Supplement III in Response to Data Requests

1 through 93 and April 25 Workshop Queries

Sun Valley Energy Project

(05-AFC-03)

FIGURE 7.1-1
PLANT WATER FLOW — ANNUAL AVERAGE FLOW
 SUN VALLEY ENERGY PROJECT
 ROMOLAND, CALIFORNIA

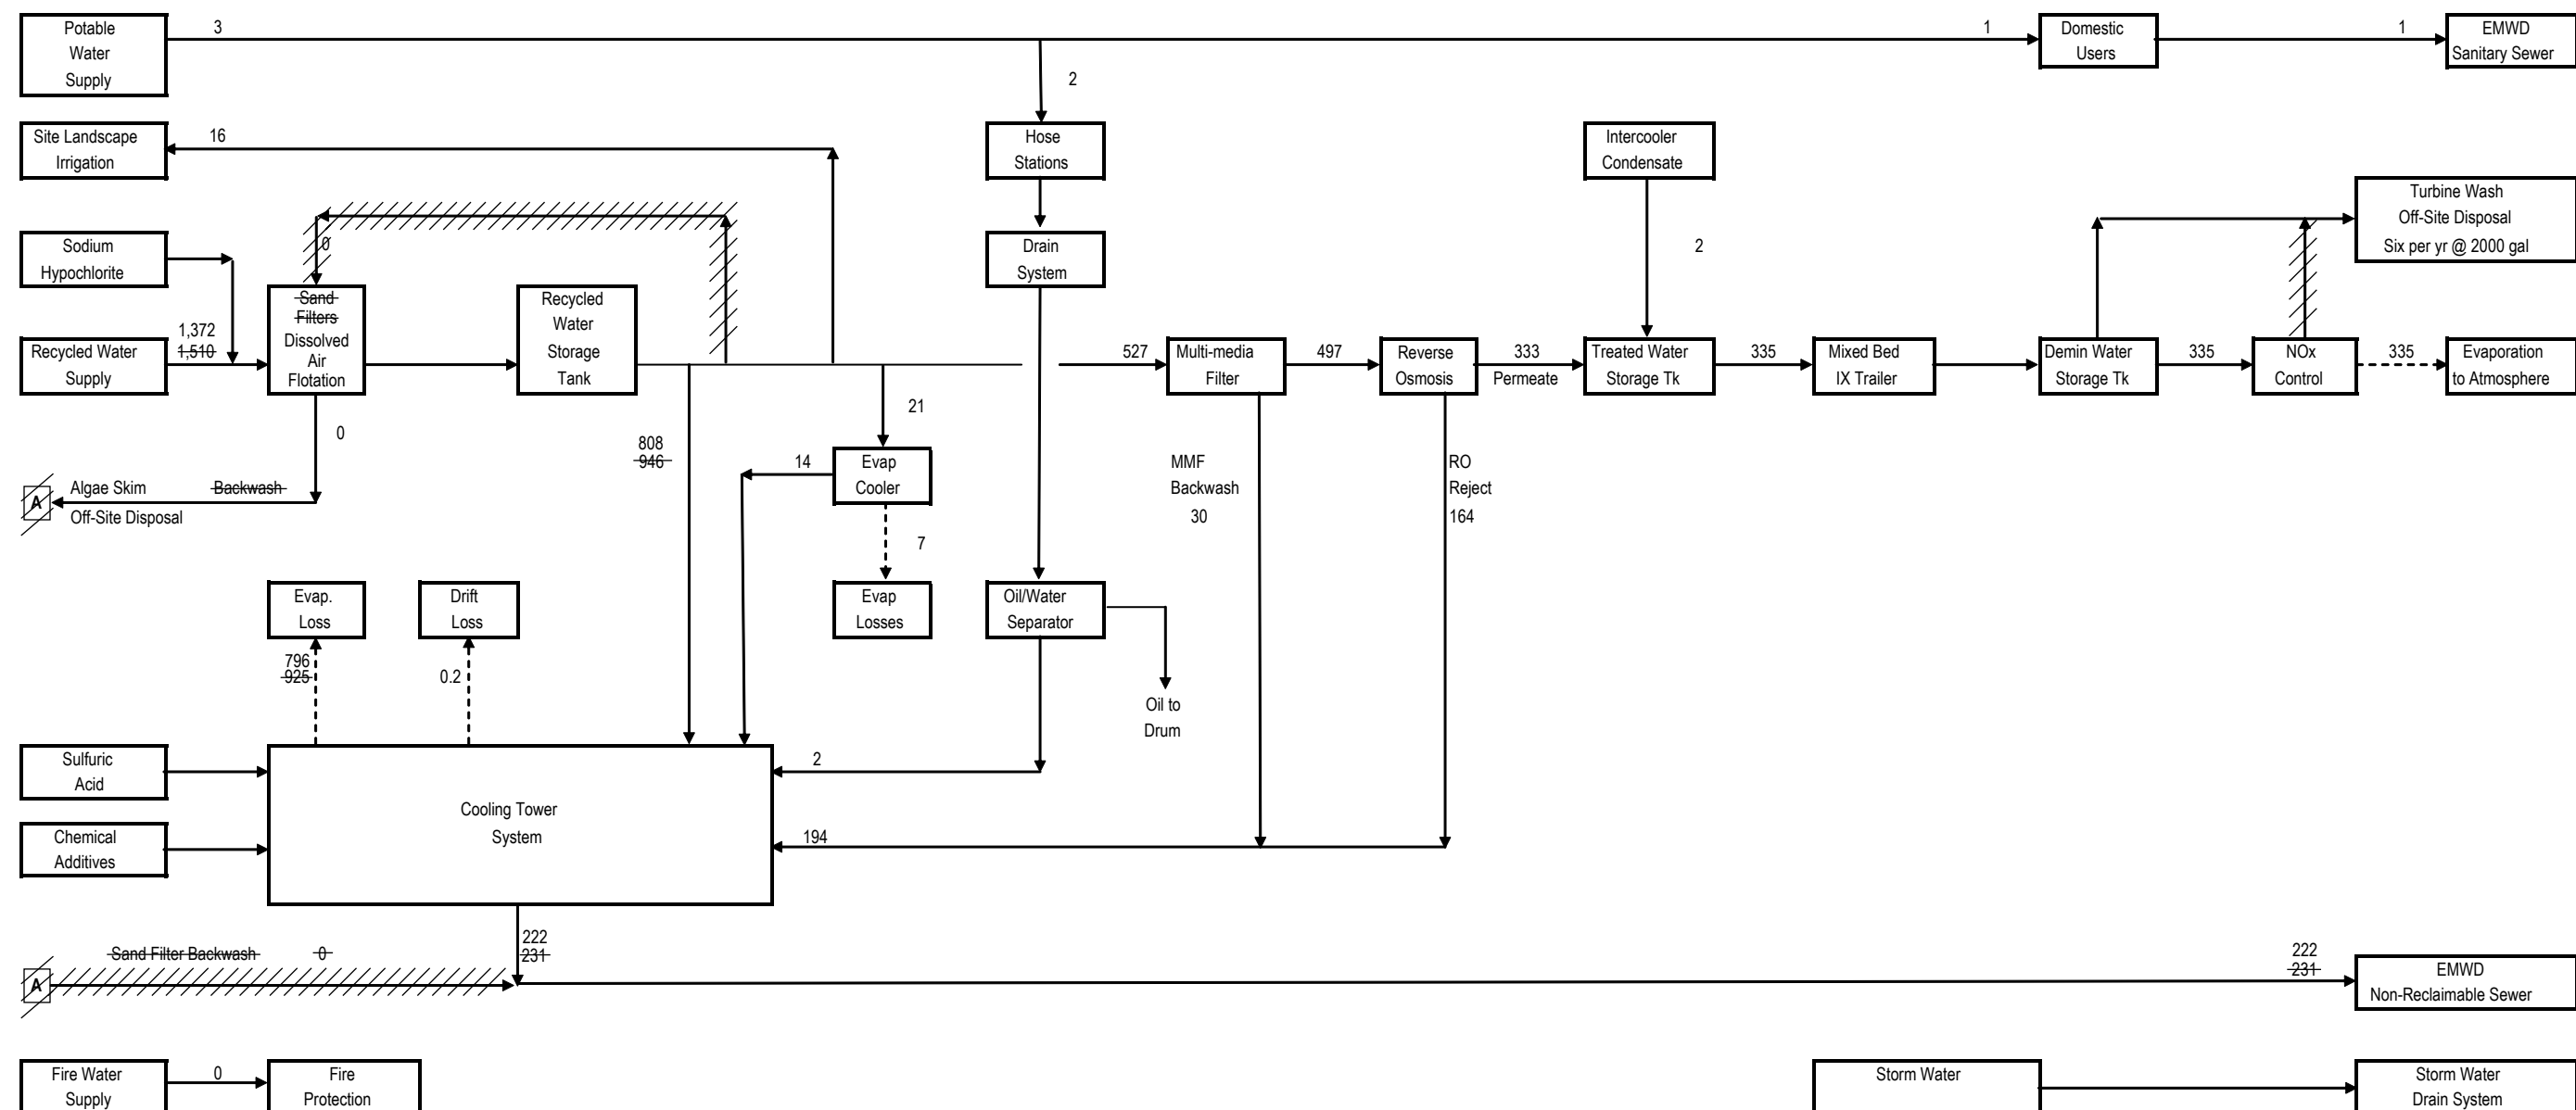
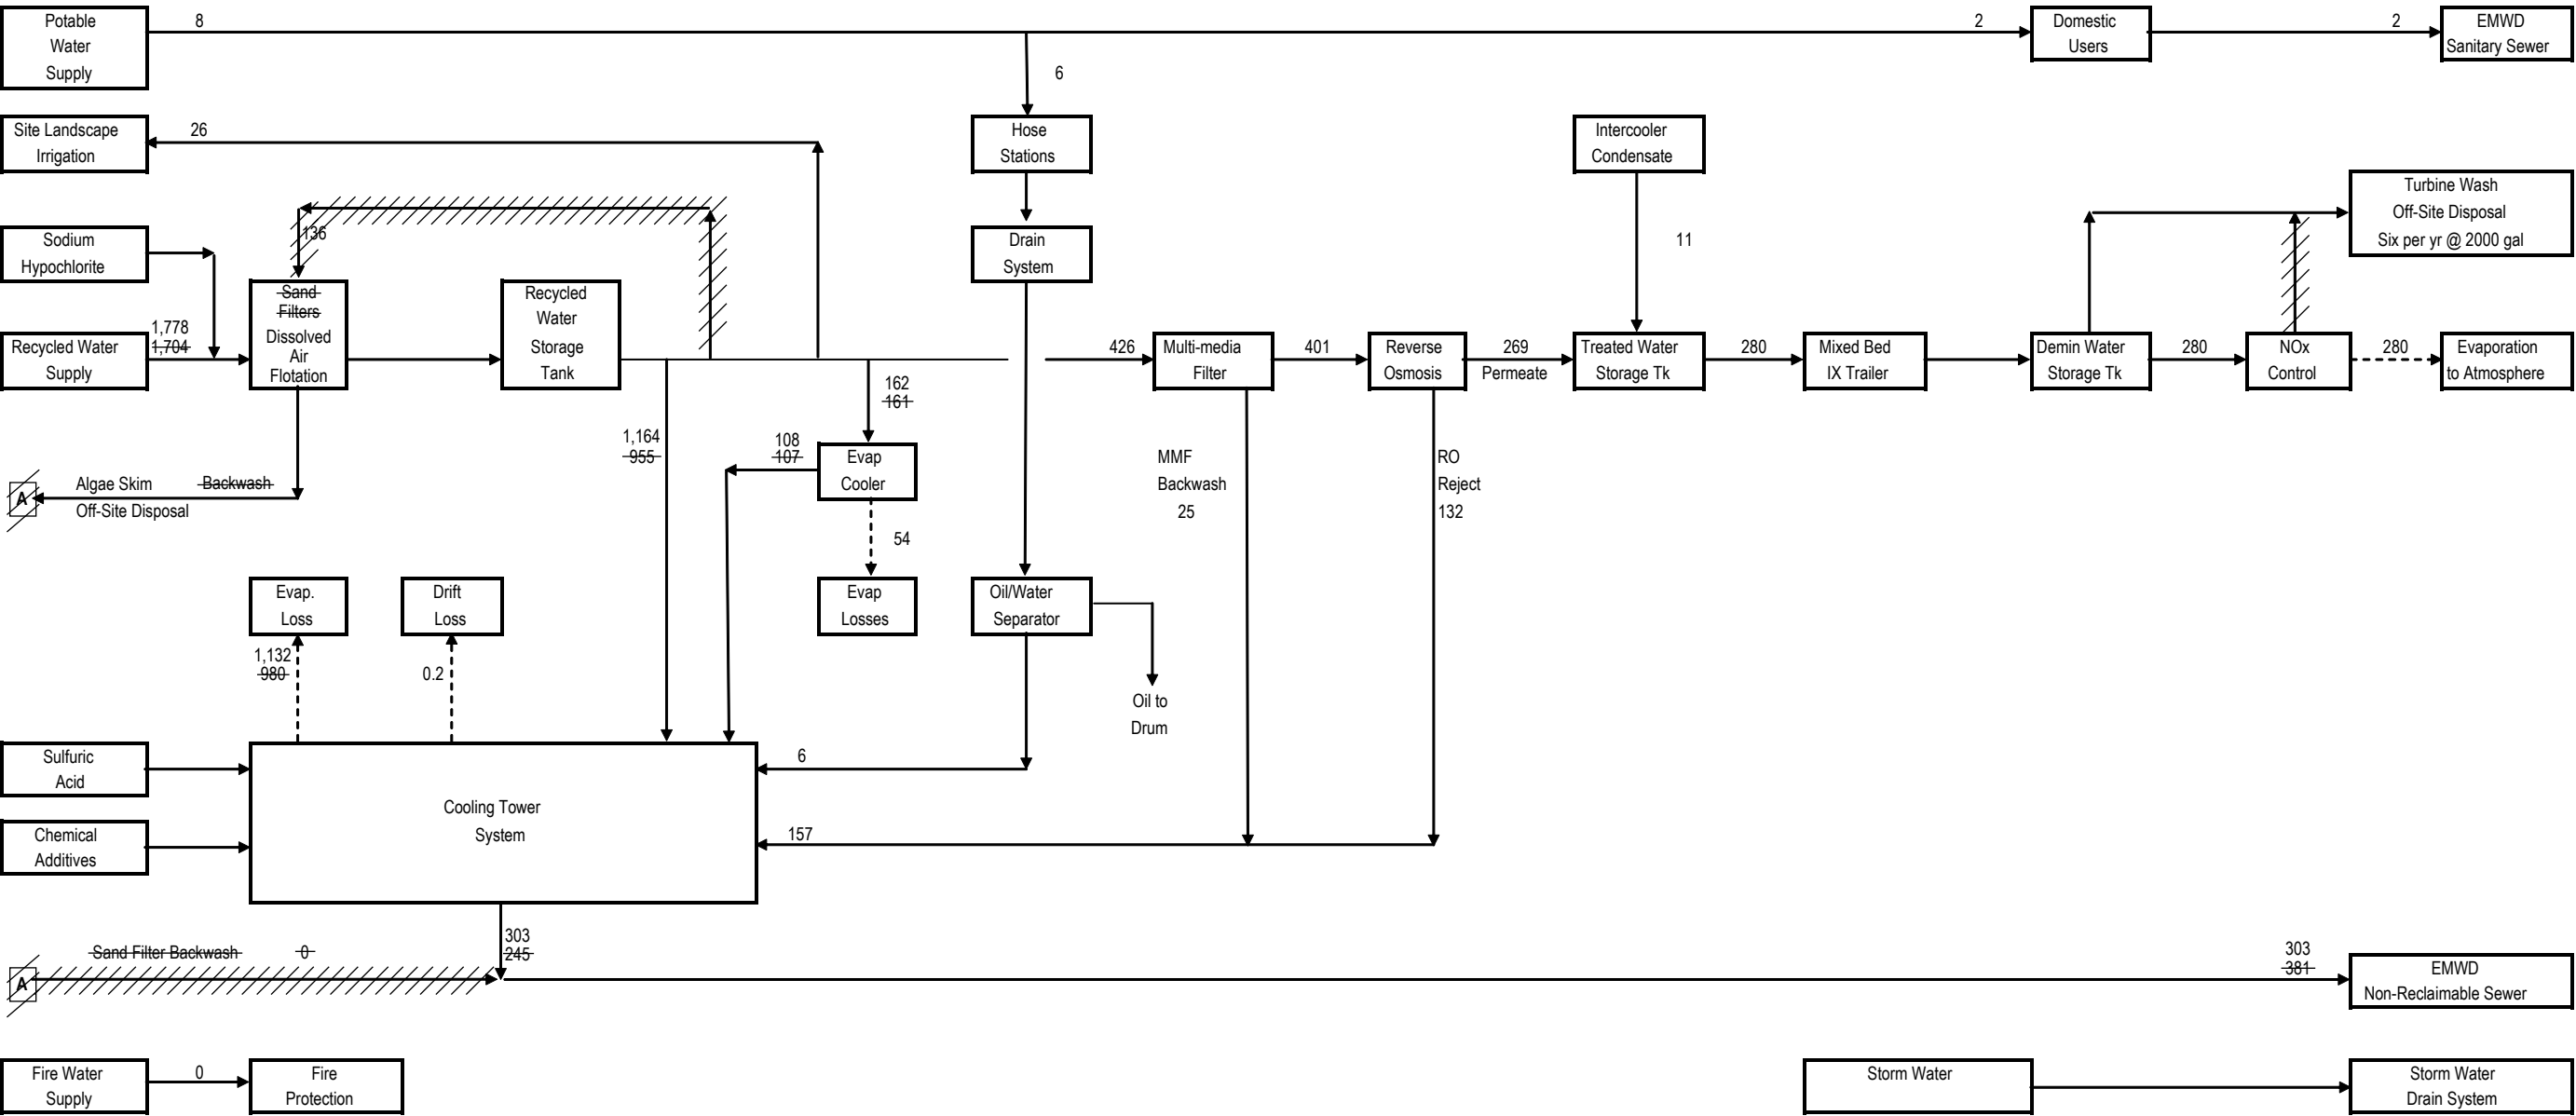
Response: Experience with an LMS-100 installation for another project, the Basin Electric Project in South Dakota, has led to changes in cooling tower design for the SVEP. Although these are minor changes, they affect various project operating parameters. Attachment VP-2 is a redline-strikethrough version of portions of the AFC (portions of Chapters 2.0, 7.0, and 8.15), reflecting these changes in design.

Water Resources—The project's use of water would change slightly. The attached redline-strikethrough version of applicable revised AFC sections (Chapters 2.0, 7.0, and 8.15; Attachment VP-2) identifies these changes in detail. The overall effect on the project's water use, however, would be negligible. The amounts of water used and discharged would not significantly change. Project wastewater discharges would not violate applicable water quality standards.

- Notes:**
- Numerical values represent steady state flow in gpm
 - ~~Dissolved Air Flotation system is Recycled Water Sand Filters~~ are used only during periods of high inlet turbidity
 - Cooling Tower Blowdown is estimated at normal maximum operating cycles of concentration (6.15 X Recycle Water Supply concentration)
 - ~~Ambient temperature assumed for this water balance is 62 F DBT/54 F WBT~~
